STATE OF MAINE
DEPARTMENT OF TRANSPORTATION
16 STATE HOUSE STATION
AUGUSTA, MAINE 04333-0016

December 4, 2018
Subject: Piscataqua River Bridge Wearing
Surface Replacement
State WIN: 019270.00
Location: **Kittery & Portsmouth, N.H.**
Amendment No. 1

ITS CONDUIT PLAN
SCALE: 1" = 100'

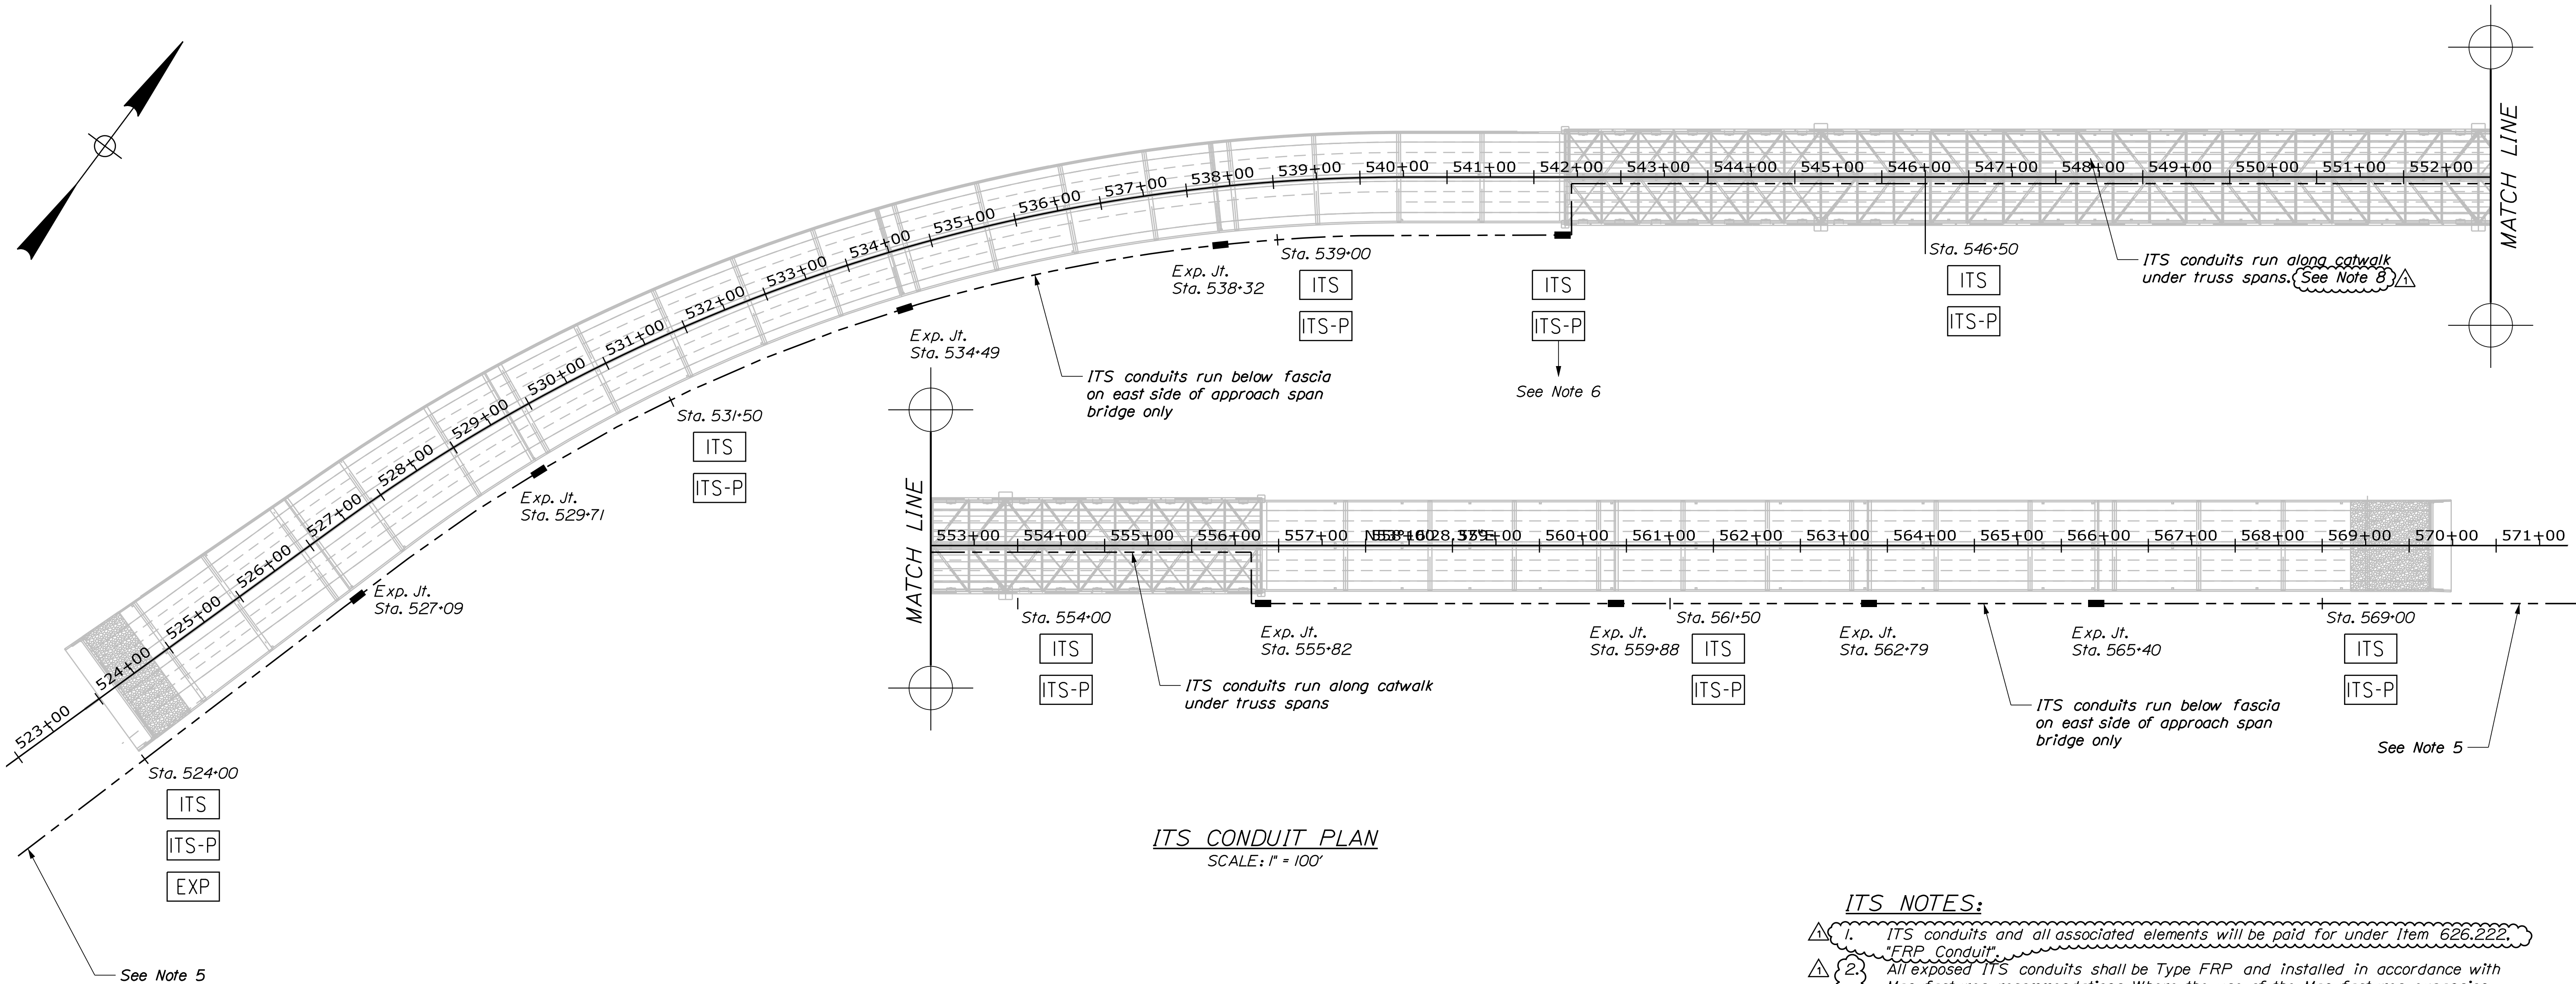
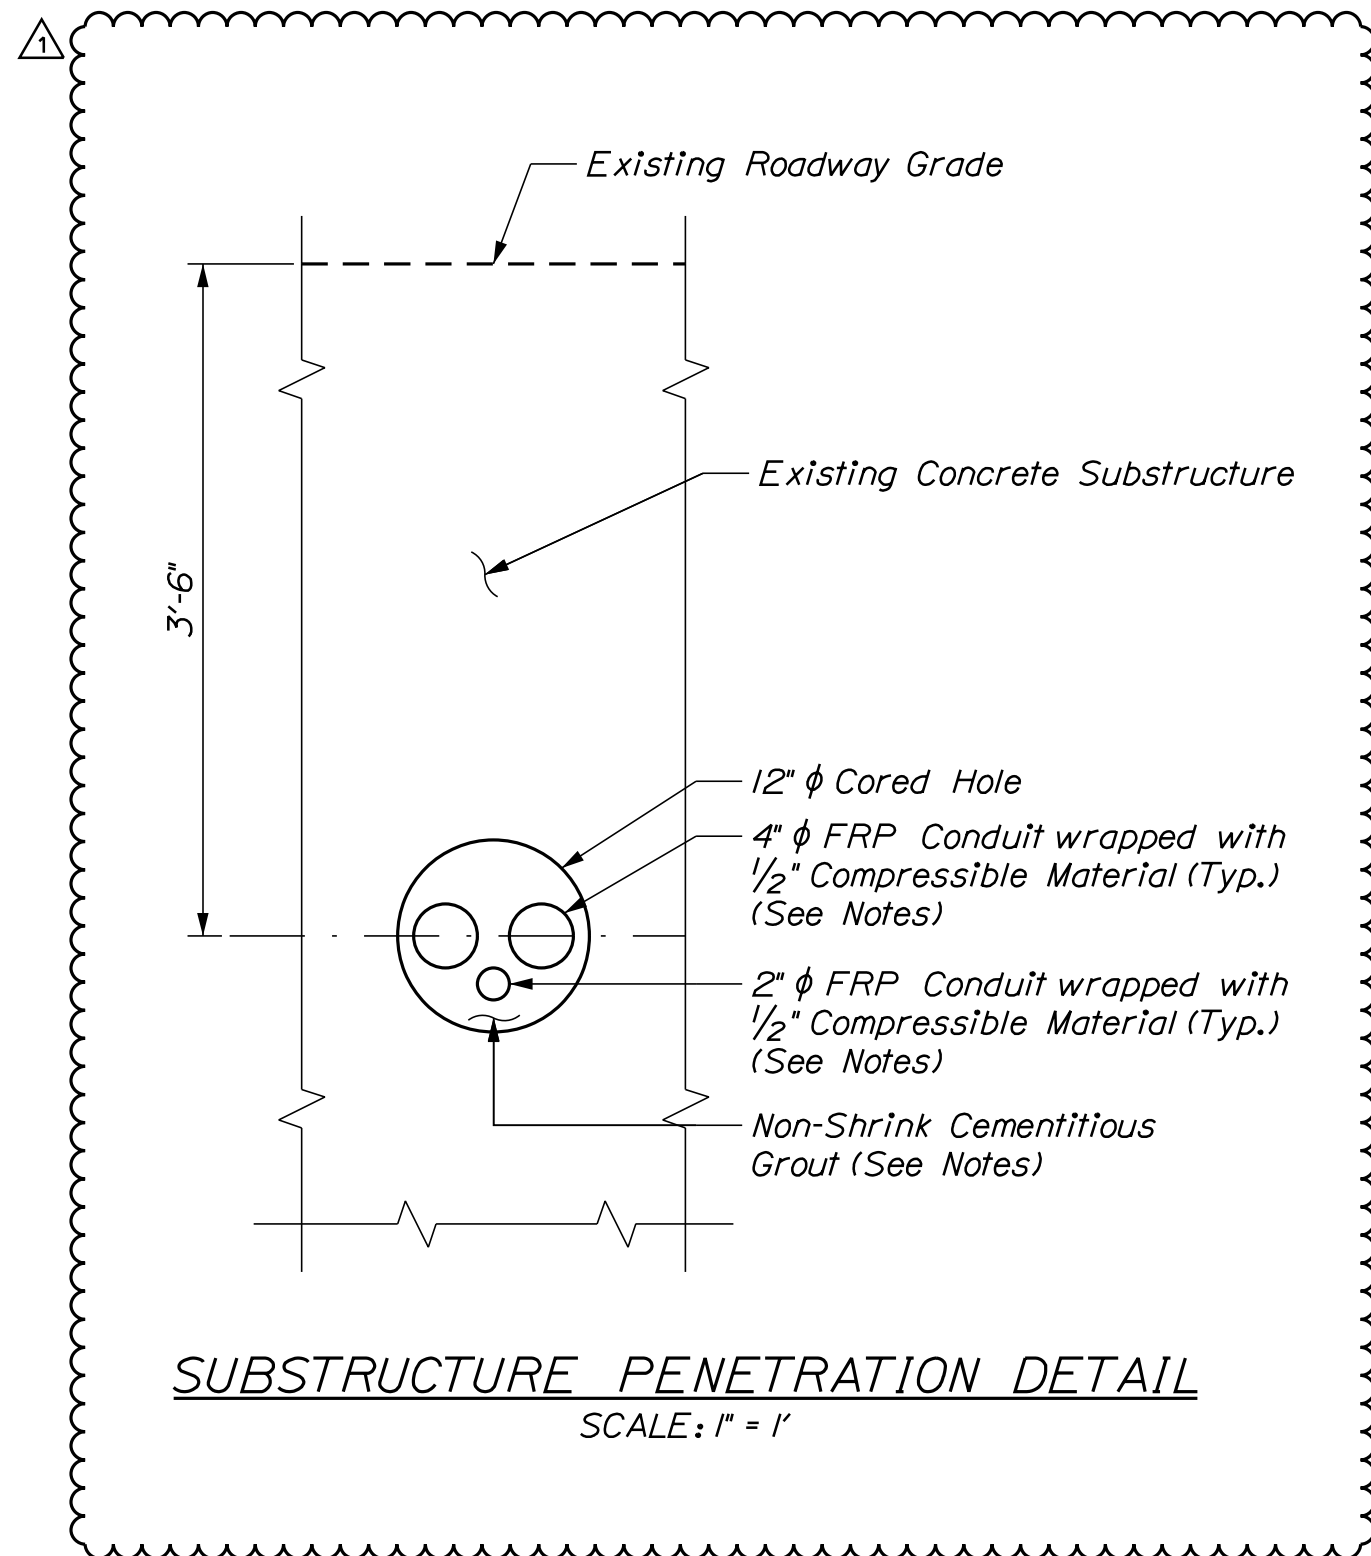
Question: Are there going to be any additional plans or an addendum coming out for the 14,500 FRP Conduit? There are no hanger details on the system.

Response: Please see revised sheets for additional information. The design of hangar details is the responsibility of the Contractor in accordance with the plans and Special Provision 626.

- Provide a conduit and pull box support system as manufactured by conduit manufacturer, consisting of FRP channels with 316 stainless steel hardware. Arrange support system such as to locate conduits and pull boxes in close proximity to catwalk system, to allow safe access to conduits and pull boxes from catwalk.
